## Reply to comments of Reviewer 1, Sharon Gourdji

## Reply to comments of Reviewer 2, Anonymous Referee

The manuscript "Effects of point source emission heights in WRF-STILT: a step towards exploiting nocturnal observations in models" by Fabian Maier and co-workers describes the use of vertical emission profiles for point sources in the time-reversed application of the Lagrangian particle dispersion model WRF-STILT. The authors convincingly show that ignoring vertical emission profiles and assuming surface emissions only, as done in many applications of LPDMs, may lead to serious biases for sites influenced by elevated point sources. The study is an important contribution for regional-scale inverse modelling of greenhouse gas emissions as it directly address shortcomings that can easily be remedied without major modifications on the transport description in LPDMs. The manuscript is well organized and written, methods and results are presented in an appropriate manner. Some minor concerns and considerations remain that I would like the authors to consider in a revised version of the manuscript.

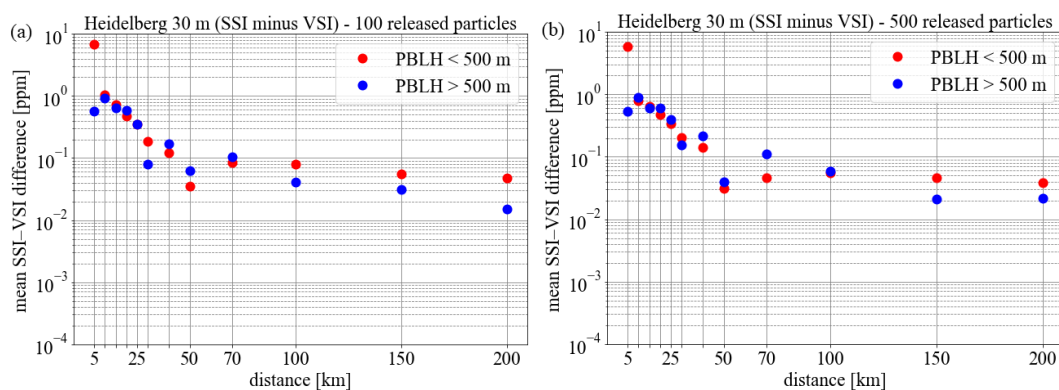
- Is 100 particles enough for this study? I assume you would get the same results using 500 particles or more, but it might be worth a small check for sensitivity here.

Thank you for pointing us to this sensitivity study. To check this, we calculated the  $\text{ffCO}_2$  contributions from the 12 pseudo power plants for the 30 m high receptor site Heidelberg by having released 500 particles. To save computational power, we considered only one month (January) in 2019. Fig. 1 shows the mean VSI minus SSI contribution differences (as Fig. 7c in the manuscript) for January 2019. The differences between 100 and 500 released particles are usually only very small. So, we can argue that 500 released particles would not change the overall picture and 100 particles are enough.

Figure 2: TNO temporal profiles for the public power (blue) and industry (orange) sectors: (a) Daily variability, (b) weekly variability and (c) seasonal variability.

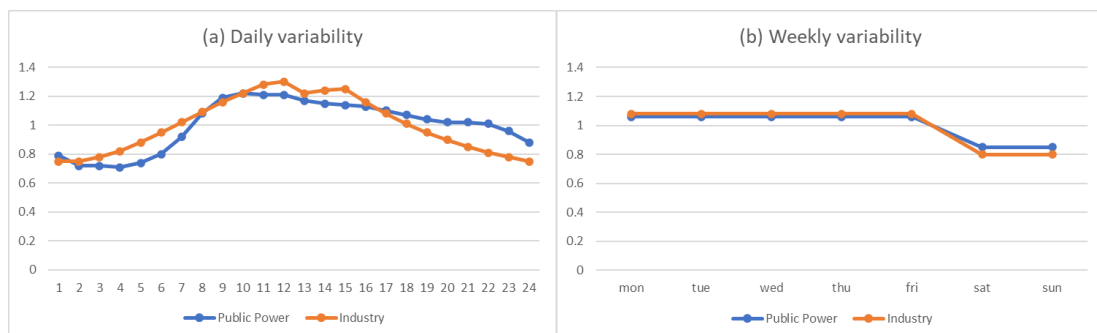
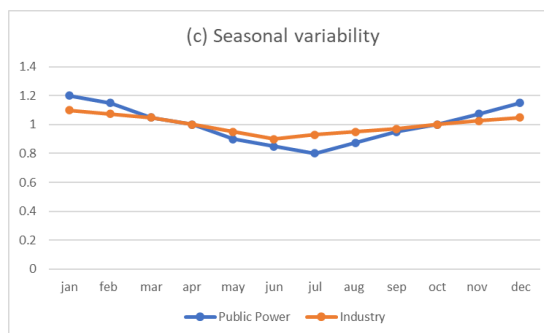
- Page 9, lines 189-191: How would time-varying emissions affect these TNO height profiles (e.g. with some emission sources starting and stopping again)? Also, do the TNO height profiles shown in Figure 3b represent sector-specific averages? Or are heights included for individual point source locations as well?

We considered in our study time-varying point source emissions. For this we used the source sector-specific diurnal, weekly and seasonal temporal profiles from TNO (see Fig. 2 below). Yes, the height profiles shown in Fig. 3b in the manuscript represent sector-specific averages, which should be representative for Europe. Unfortunately, there are no stack heights for individual point source locations available. We have added a few sentences in our revised manuscript (lines 226ff).

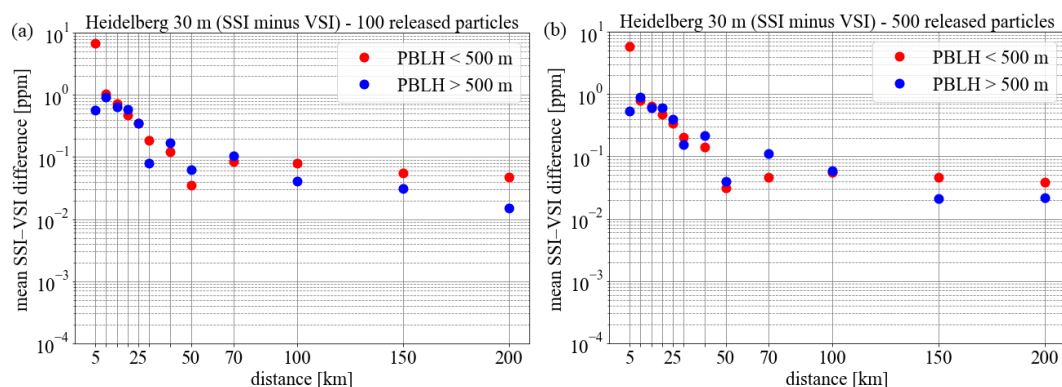
L138: One hundred released air parcels per hour seems to be very small. How can one statistically resolve any vertical gradients with these? The VSI approach requires five different layers as applied here, the lowest two with a thickness of only 100 m. How can you be sure that one hundred air parcels can robustly represent any vertical gradient in such thin layers? The previous  $h_{pbl}/2$  method may have allowed for such small air parcel numbers because no vertical gradient below  $h_{pbl}/2$  had to be represented. The improved results with the VSI approach seem to justify the small number of air parcels, but they may merely result from improved separation between stable PBL and lower free troposphere at night. The lack of improvements during daytime (from SSI to VSI) may indicate that residence time gradients during the day are not well represented by the limited number of air parcels.

We agree, a larger number of released particles would increase the statistics and may also lead to a better resolution of the vertical gradients, especially during situations with large planetary boundary layer heights (PBLHs). To investigate the effect of a larger number of released particles, we calculated the  $ffCO_2$  contributions from the 12 pseudo power plants for the 30 m high receptor site Heidelberg by having released 500 particles. To save computational power, we considered only one month – January – in 2019. Fig. 3 shows the mean VSI minus SSI contribution differences (as Fig. 7c in the manuscript) for January 2019. The differences between 100 and 500 released particles are usually only very small. During situations with large boundary layer heights ( $PBLH > 500$  m), the mean SSI minus VSI difference in the  $ffCO_2$  contributions from the pseudo power plants differs no more than 0.08 ppm for the two cases with the 100 and 500 released particles, respectively. Although the increased number of released particles can lead to some deviations, it should not change the overall picture, even for situations with large mixing heights. Based on these findings, we only released 100 particles to save computational power. We have added a note about this in the revised manuscript (lines 160ff).

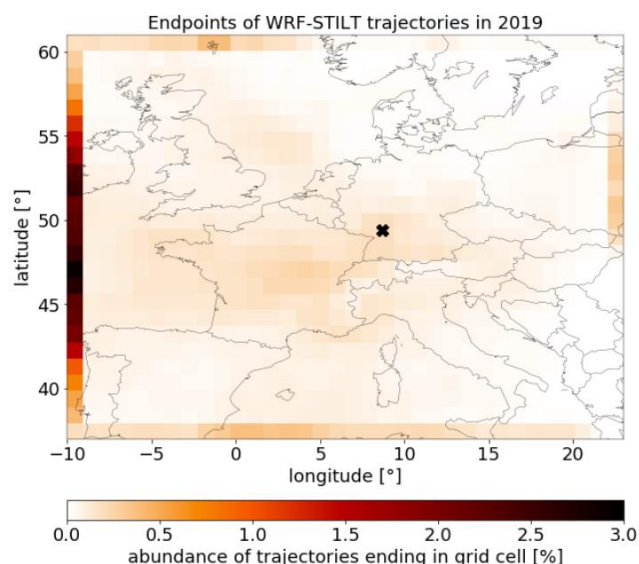
L139: Considering the outer WRF domain, this backward integration time seems to be rather short. What is the reason for the selected 3 days? How frequently do particles remain within the domain after 72 hours?

This is true, the rather short backward integration time of only 3 days results in 50.3 % of the trajectories remaining within the domain in 2019. Fig. 4 shows the distribution of the  $365 \times 24 \times 100$  trajectories' endpoints in 2019. The trajectories with endpoints within the domain end mainly over Central and Western Europe and over the Atlantic Ocean. To estimate the influence of the backward integration time, we calculated 10 days-backtrajectories for a winter and summer month in 2019 and compared the modelled SSI  $\text{ffCO}_2$  concentrations with those obtained with the 3 days-backtrajectories. Here, we used the SSI approach, since we have shown that it leads to similar far-field (well-mixed)  $\text{ffCO}_2$  contributions as the VSI approach. In January 2019, when 28.9 % of the 3 days-backtrajectories end within the domain, the 10 days-backtrajectories lead in the median to 0.09 ppm larger  $\text{ffCO}_2$  contributions than the 3 days-backtrajectories. In July 2019, 65.7 % of the 3 days-backtrajectories end within the domain and the median  $\text{ffCO}_2$  difference between 10 days- and 3 days-backtrajectories is 0.22 ppm. Thus, the usage of 3 days-backtrajectories instead of 10 days-backtrajectories results in a slight underestimation of the modelled  $\text{ffCO}_2$  concentrations (Fig.4 in the manuscript), which affects the SSI and VSI approach similarly. However, considering the potential bias introduced by assuming that Mace Head is a representative  $\text{ffCO}_2$  background for the whole domain border (i.e., ignoring for example a continental background for trajectories ending at the eastern domain border) this 10 days- vs. 3 days-backtrajectories bias seems to be rather small. To save computational power for the high-resolution simulations we therefore used a backward integration time of only 3 days. We have included a note about this sensitivity study in the revised manuscript (lines 160ff).

Figure 5: TNO diurnal profile for public power (blue) and industry (orange) emissions.

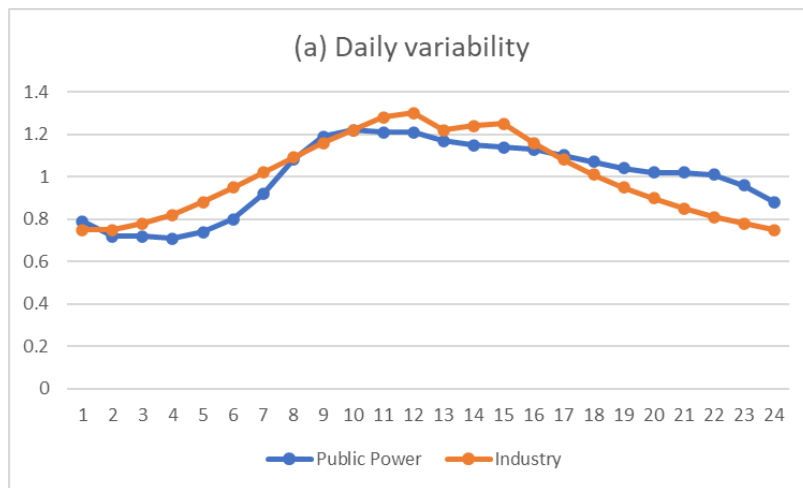
L394: Connected to the previous comment. Is this true? What is the diurnal profile that is applied to large point sources in the present simulations? This may well be different for different point sources. Can you be sure that the nearby point sources mentioned in section 2.1 can be represented well by the applied diurnal profile? A day/night difference of 50 % seems likely for a combined heat and power plant that can react relatively quickly to energy demands.

We used the source sector specific diurnal profiles from TNO (see Fig. 5 for the diurnal profiles for the most important energy and industry point sources). We agree that these profiles can have large uncertainties, especially when applied to individual point sources. An advantage could be that we analyse two-week integrated samples, which have seen different point sources depending on the meteorological situations. Thus, we are maybe less influenced by one specific point source and get a more mixed signal from different point sources. However, this would not help if the diurnal (day vs. night) emission profile is wrong for all point sources. We wanted to investigate this in Fig. 8 in the manuscript. It shows that the nocturnal point source emissions would have to be decreased by 70 % to get a similar performance (in terms of RMSD between modelled and observed ffCO<sub>2</sub>) for the SSI and VSI approach. Since the averaged daily point source emissions seem to be relatively well known, this would mean that the point source emissions have to be significantly increased during the day so that the 70 % reduction during night is compensated. Since we already have applied a diurnal profile with nocturnal emissions being 24 % (energy) and 34 % (industry), respectively, lower than during the afternoon, the day/night difference would be much more than 50 %. We consider such large deviations as highly unlikely.
